Access Audit Final Site Report

**Gary Morava Recreation Center
110 W Camp McDonald Rd
Prospect Heights, IL 60070**

**Inspection Date: 02/29/2024
Inspectors: Shelley Zuniga**

Prepared By
WT Group

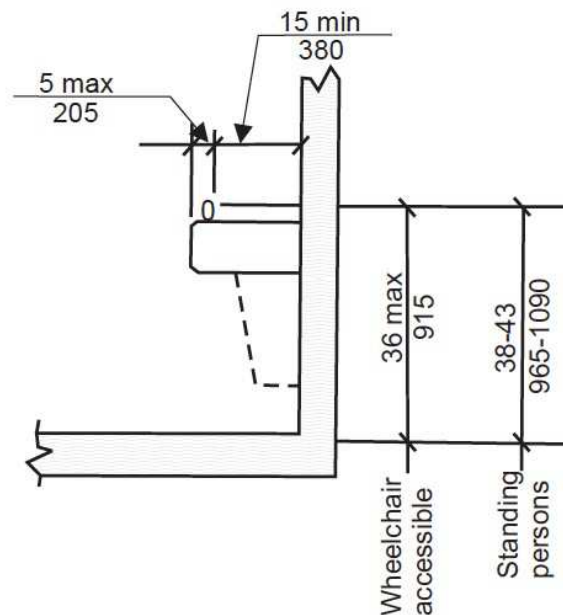
Lower bowl drinking fountains shall provide knee and toe clearance centered on the unit.

Add second low bowl fountain for persons using wheelchairs.

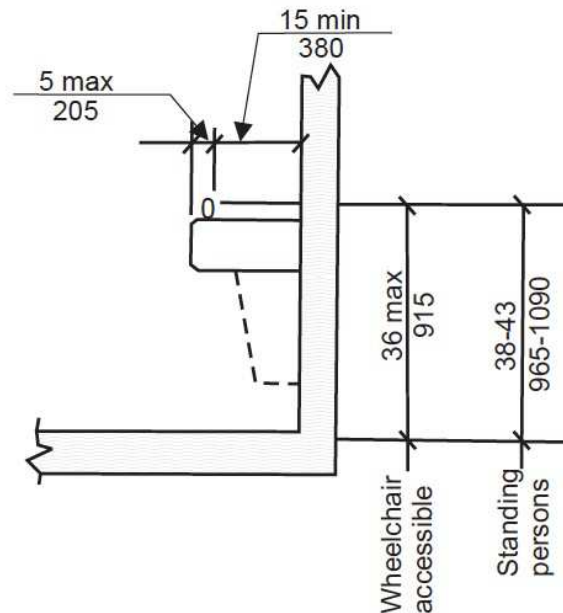
Lower bowl drinking fountains shall provide knee and toe clearance centered on the unit.

Add second low bowl fountain for persons using wheelchairs.

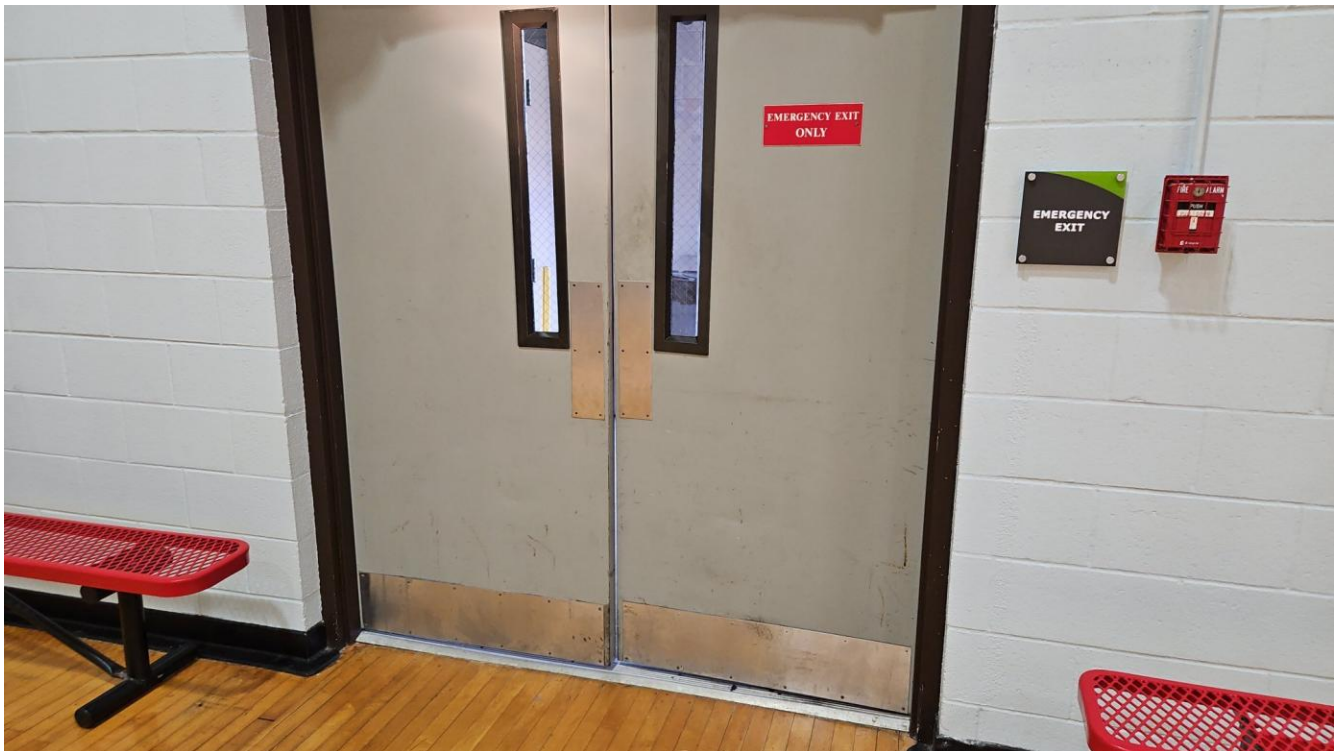
Gym exit - one door
6#, other door closes
fast

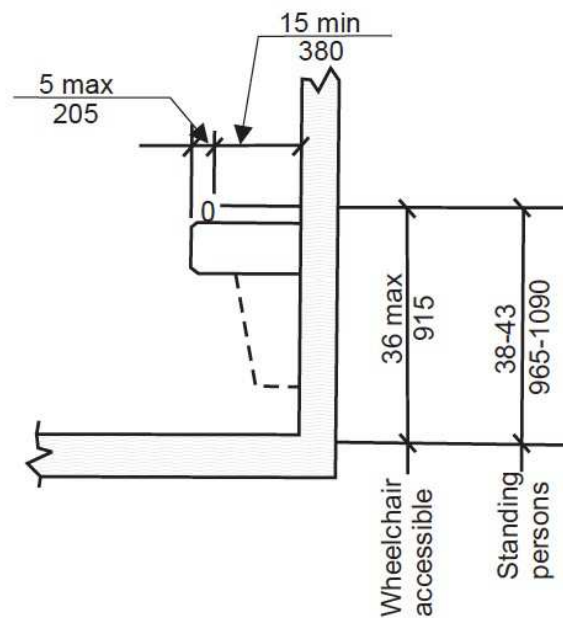
When drinking fountains are provided, a minimum of one must be designed for wheelchair users and one must be designed for standing persons unless a single fountain meets the requirements for both.

Replace drinking fountain with hi-lo bowl

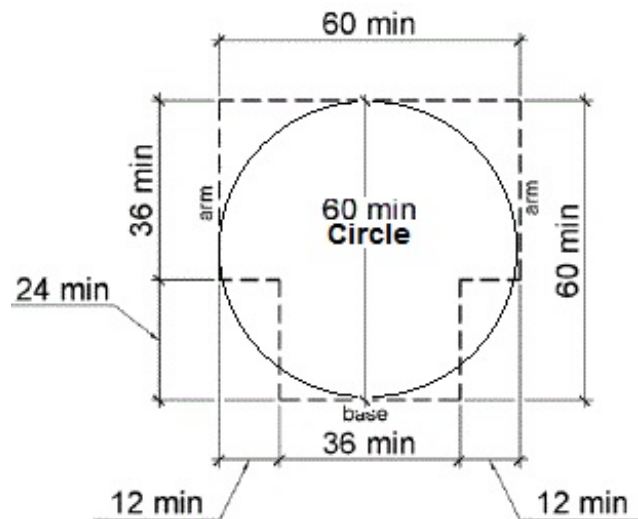
Steam and sauna rooms must provide a 60 inch diameter turning space or "T" turn within the room.

Provide required turning space within steam/sauna rooms if feasible or replace unit with an accessible unit.

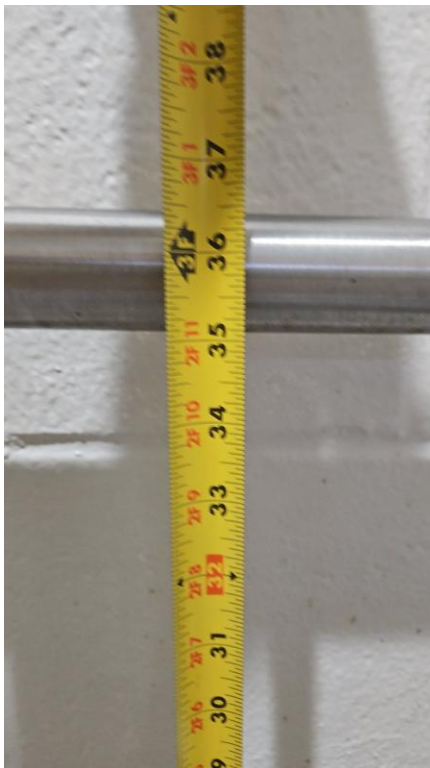
grab bars 36.5" and 36.75", TP 3.5" above side bar and too far from toilet

105D women's sauna - wall back pull side, 21" wide, 2" CIL, 54" window

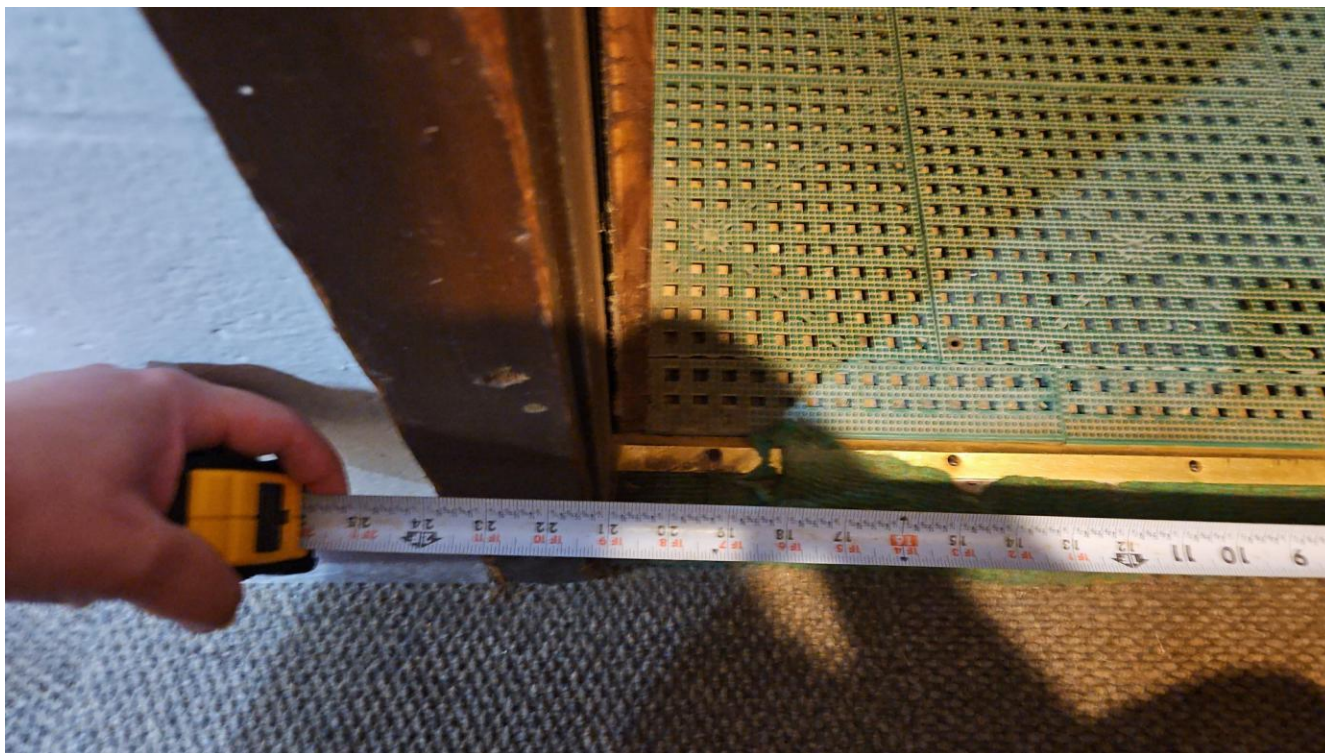
The threshold has a vertical change greater than 1/4 inch high.

For all doors/gates along the public circulation route, provide required maneuvering clearance on push and pull side of doors/gate.

For all doors/gates along the public circulation route, replace with doors/gates having 80" overhead clearance and 32" clear width.

For all doors/gates along the public circulation route, replace doors/gates with ones having sidelight viewing windows max 43" AFF.

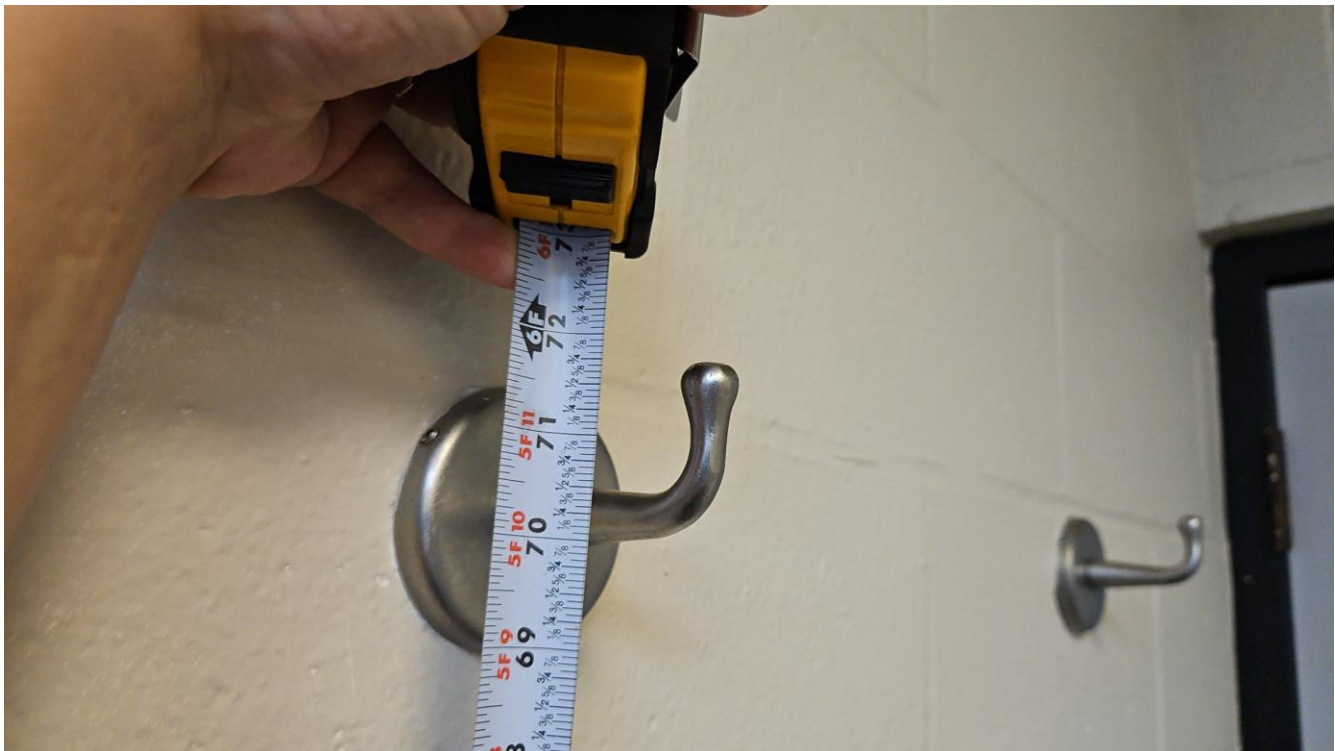
hooks 71.5" AFF

Remount at least one hook to max 48" AFF.

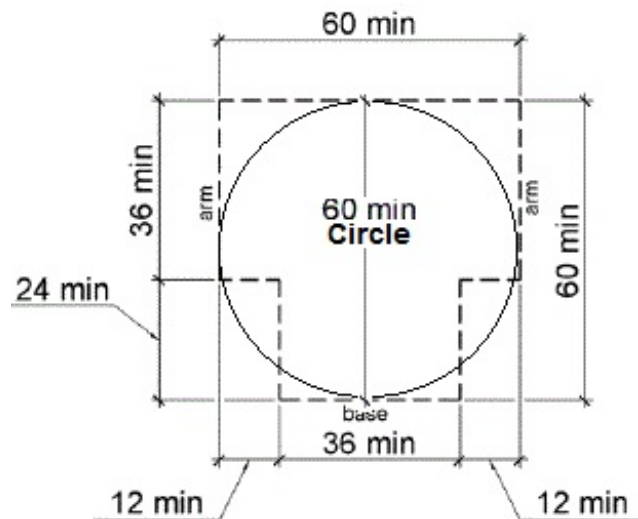
Steam and sauna rooms must provide a 60 inch diameter turning space or "T" turn within the room.

Provide required turning space within steam/sauna rooms if feasible or replace unit with an accessible unit.
